KANSAS DEPARTMENT OF AGRICULTURE
Division of Water Resources
M E M O R A N D U M

DATE: October 19, 2016
RE: Water Right
File Nos. 1,062; 8,809-D1;
12,819; 18,011; 35,530 and
35,531

**APPROVAL OF APPLICATION
FOR
CHANGE IN PLACE OF USE
POINT OF DIVERSION AND USE MADE OF WATER
ORDER REDUCING THE AUTHORIZED QUANTITY AND DIVERSION RATE
AND MODIFYING THE ADDITIONAL LIMITATION ON THE AUTHORIZED
QUANTITY AND DIVERSION RATE
WATER RIGHT
FILE NO. 8,809-D1**

GMD3 Change Review

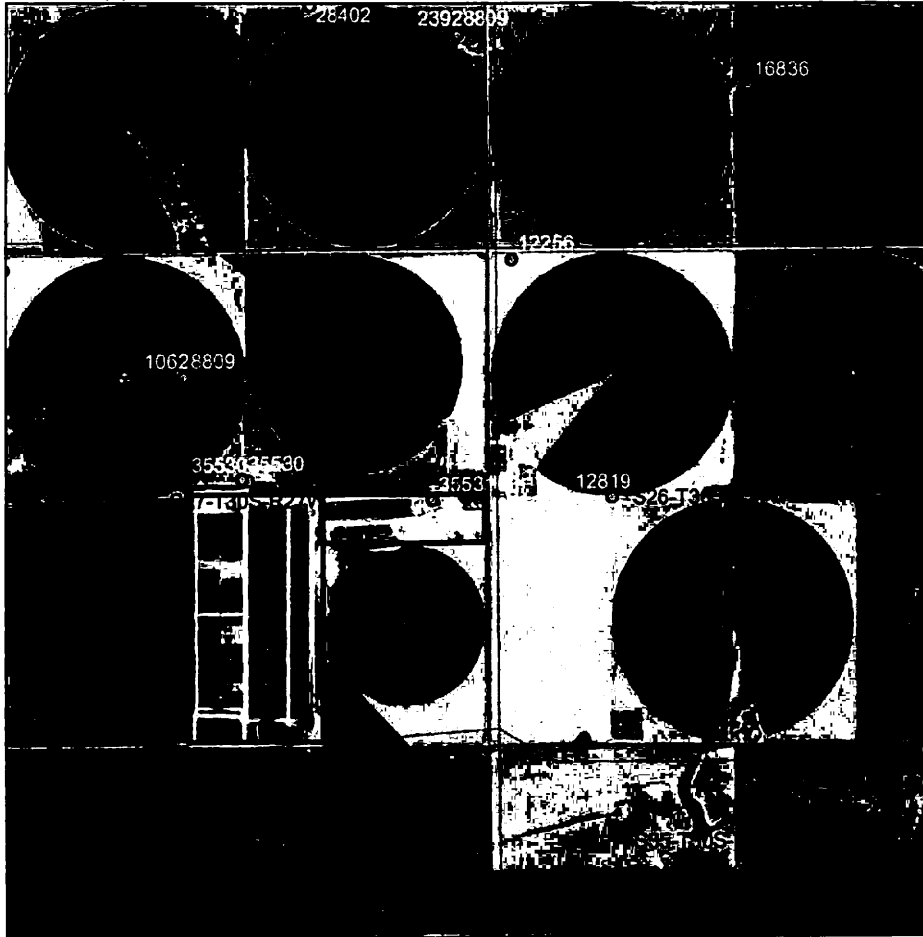
Red outline is current PU for STK watering and the solid red is new area proposed for expansion. This is on the applications filed for WRs 8809D1 STK, 35530 & 35531. A change in place of use was made for WRs 1062, 8809D1 IRR, 12819 & 18011. The changes will still completely overlap place of use for all WRs, but had to be adjusted for the partial change in Use Made of Water, the feedlot expansion and to better show the actual place of use.

Final Recommendation: The applications to change place of use meet the criteria under KAR 5-5-11 and we recommend approval.

The change under 8809D1 requires a waiver to spacing to neighboring wells. This existing wells is not going to be able to utilize the full depth of the well due to casing failure and the applicant state that it is intended to only be used during peak demand like in summer in order to keep feedlot system working properly. Staff and Board therefore recommend a waiver and approval of the application.
